# Suggested changes to COM

Adee Ran, Intel Corp.

P802.3bj task force, May 2013, Victoria

# DFE limitation in KP4 – illustrated

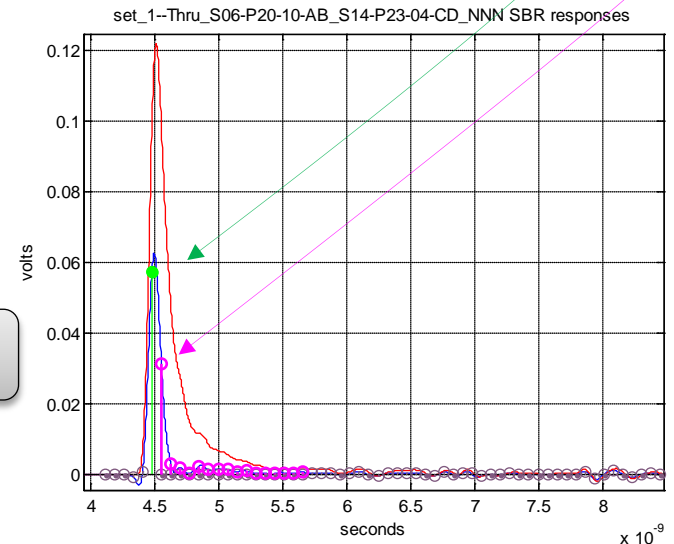
- DFE limitation (for KP4) intended to prevent error propagation, but is applied to 1<sup>st</sup> postcursor too
  - 1<sup>st</sup> postcursor error propagation is mostly protected by the KP4 precoder; it is assumed that large value is allowed
  - This causes unjustified degradation for lossy channels in KP4
    - Example: Emerson longest: if change applied, 3.4 dB → 4.6 dB
- **Proposal:**
  - Split the second case into two cases,  $n=1$  and  $2 \leq n \leq N_b$
  - For  $n=1$ , use 1 instead of  $b_{\max}$
  - For  $2 \leq n \leq N_b$ , use the existing equation
  - See [backup](#) for comparison

Comment #80; remedy also addresses #158 by Adam Healey

- Resulting available signal: 14 mV (44/3)
- 1<sup>st</sup> postcursor: 0.19\*cursor
- COM=3.45 dB

- Resulting available signal: 19 mV (57/3)
- 1<sup>st</sup> postcursor: 0.55\*cursor
- COM=4.49 dB

# COM effect on receiver jitter

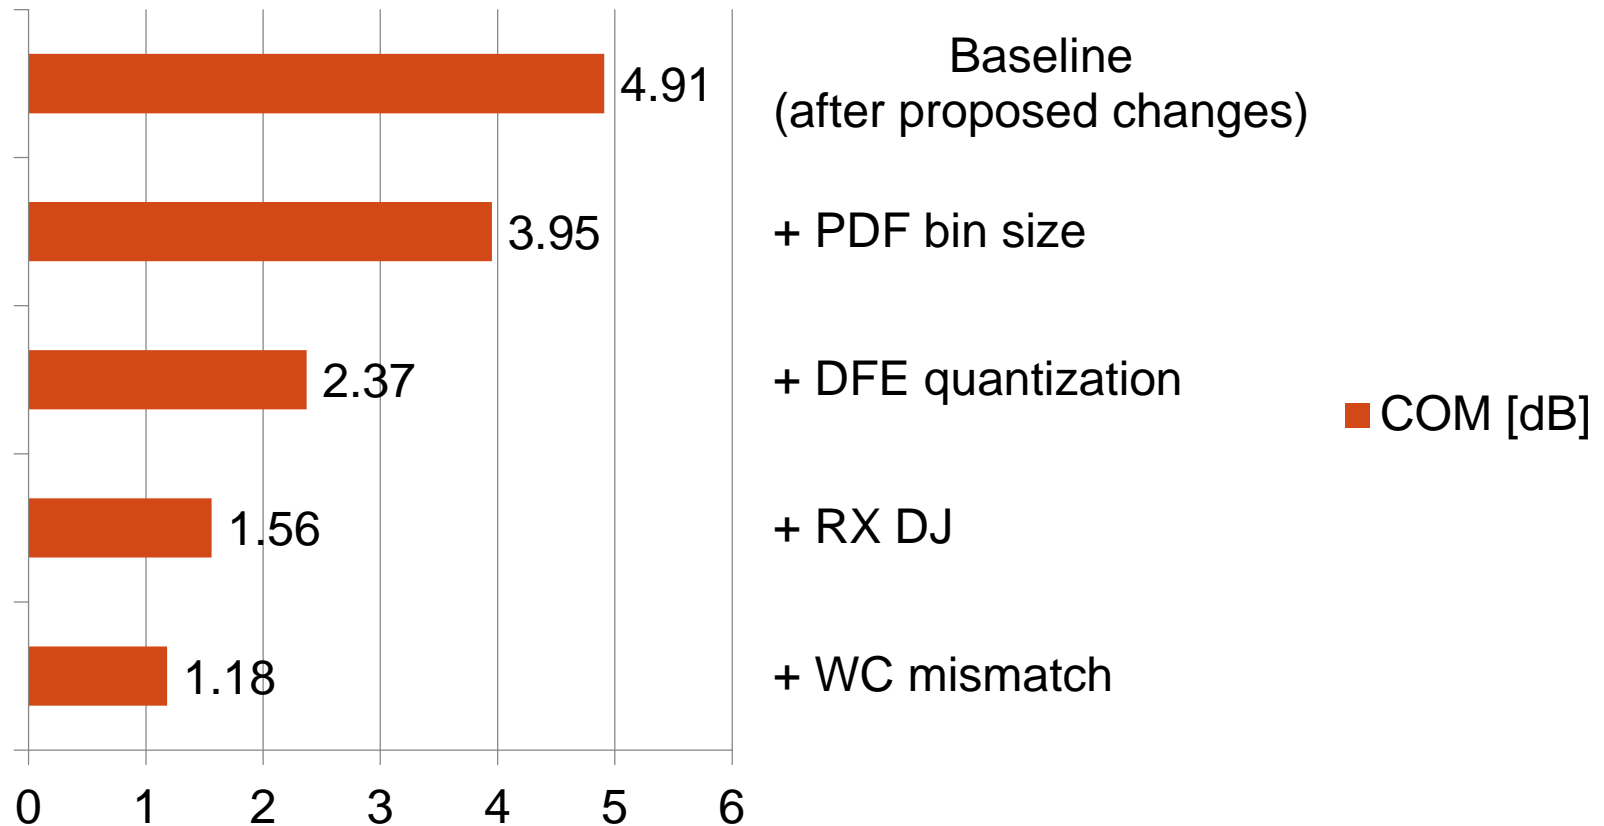
- 3 dB means that at the target BER, the vertical eye is  $10^{-(3/20)}=70\%$  closed
- Practical receiver implementation can only make it worse (quantization etc.)
  - But say the actual eye is still not completely closed – is it OK?
- The receiver is required to track low frequency jitter; required tracking capability (“bandwidth”) is implied from TX jitter specs, and verified in RX jitter tolerance tests
  - Closing the eye reduces the effectiveness of phase detectors
  - For a given “bandwidth”, the more closed the eye, the more receiver jitter is created.
- Receiver jitter is an “implementation penalty” that depends on COM!

# Conversion of jitter to noise

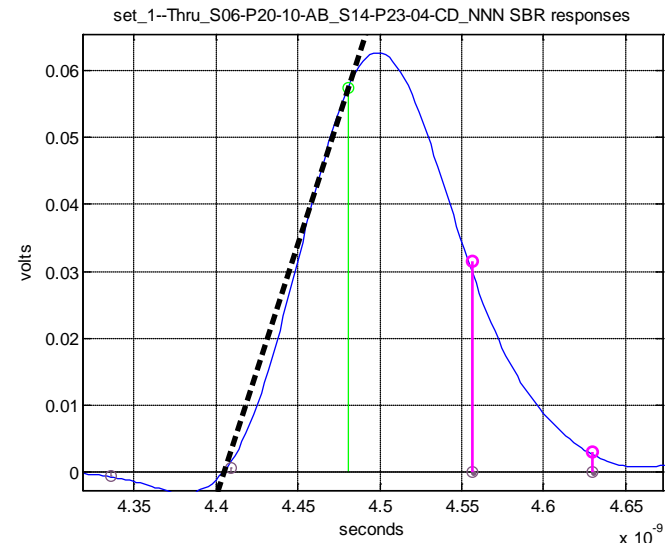
- Simplifying assumption: jitter moves the sampling phase along the slope of the rising edge.
  - The pulse starts at a zero crossing at the precursor and reaches the signal level  $A_S$  at the cursor
  - A linear approximation is that the slope is  $A_S$  [volts/UI]
- Thus, jitter is converted to voltage noise by linear scaling of the jitter PDF to noise PDF, and the conversion factor is  $A_S$  – easy to specify and compute.
- Precursors and postcursors typically have smaller slopes so their “contributions” are lower. Accounting for them makes the analysis much more complex, without significant change of the result.
  - Requires calculation of conditional probabilities of cancelling/adding-up combinations of slopes.
  - Not as easy as convolutions...
